# **MAGWATCH**

# **SUMMARY OBJECTION**

**APP/23/00822/F**

May 2025

Figure 1 - Proposed Site Layout

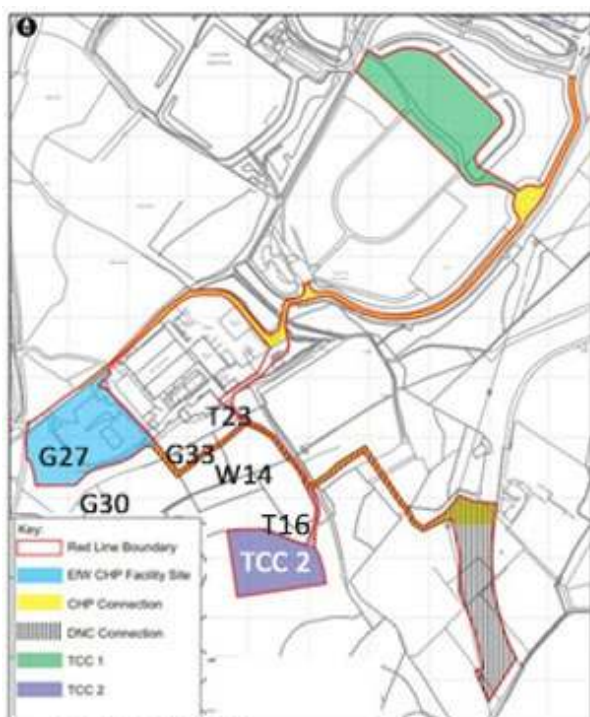
'No objection on biodiversity grounds, providing planning condition which precludes use of TCC2 is implemented.'

'In the absence of clarity in regard to the method of undertaking arboriculturally sensitive works and the lack of detail regarding the removal of protected trees and sections of woodlands along the cable run, *the proposal can not be fully assessed or supported at this time.*'

Figure 4-8: Final refined EfW CHP Facility Site layout

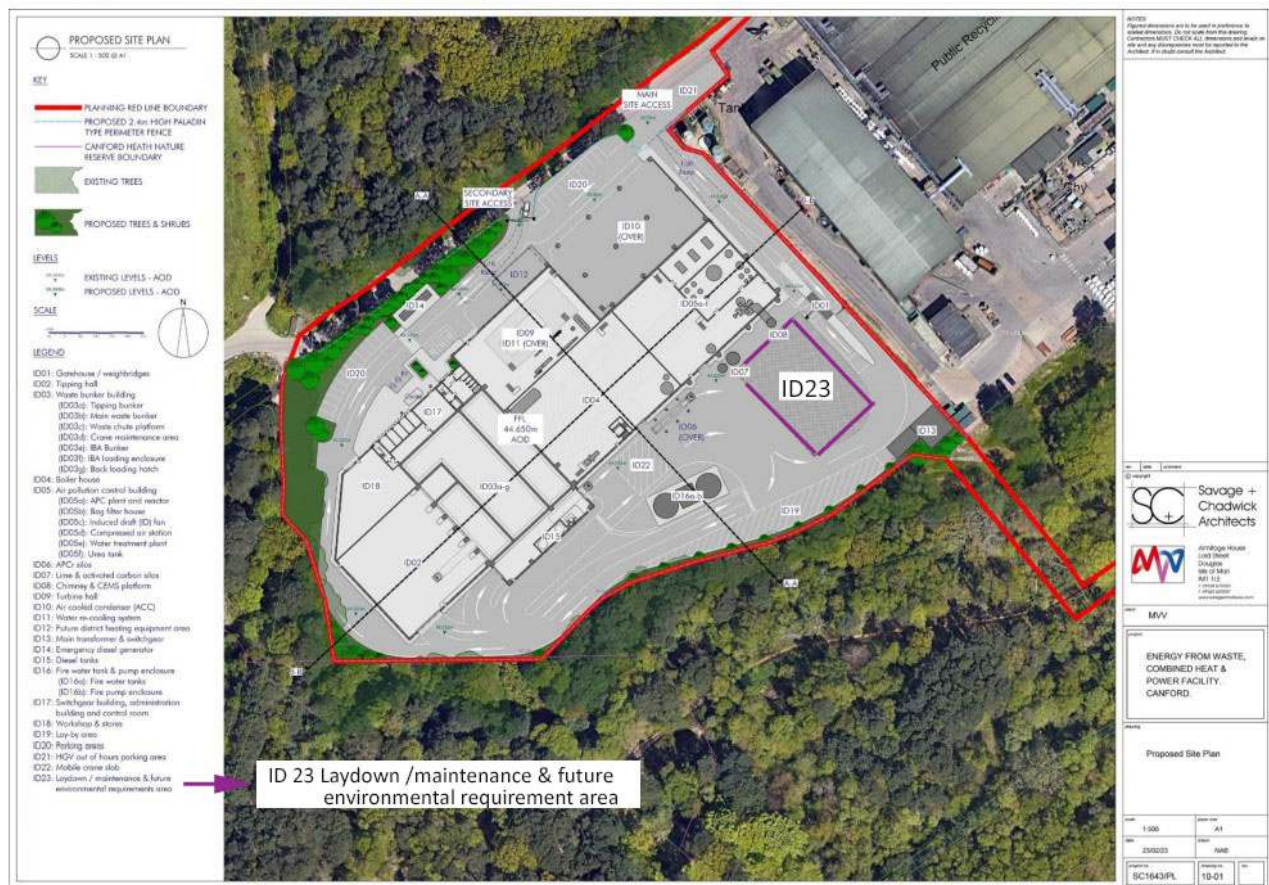
The layout includes an area identified as maintenance and laydown space which could also be used for future environmental requirements, that is carbon capture – ID23 on the above plan. [See MVV Figure 4-8 above.]

As part of his review of the Portland incinerator application, Planning Inspector Paul Griffiths conducted a qualitative comparison between the Portland and Canford sites. His findings – accepted by the Secretary of State in September 2024 – were that the land allocated by MVV for the retrofit carbon capture facility

‘The land in question appears to be around 900 square metres in area which is a fraction of what would be required for a CCS facility serving an ERF of the scale proposed’ and that

‘the Canford scheme cannot, therefore, deliver a deployable CCS plant in the only location identified for it.’ (8.64 )

it is hard to see how a retro-fitted CCS can be accommodated within the current application site or how the site could be extended without being in breach of current planning guidance.

1. A detailed and feasible site plan showing the full CCS infrastructure's footprint, demonstrating that there is adequate space within the site allocated by the BCPD Waste Plan.
2. An updated air quality assessment to account for new emissions from the CCS process, including potential amine emissions.
3. A revised biodiversity impact assessment considering additional land requirements and operational effects, such as habitat loss, disturbance and damage.
4. An updated hydrological and ecological impact assessment, with full analysis of projected water use and contamination risks.
5. A thorough analysis of the traffic impact of the transportation of liquid carbon.
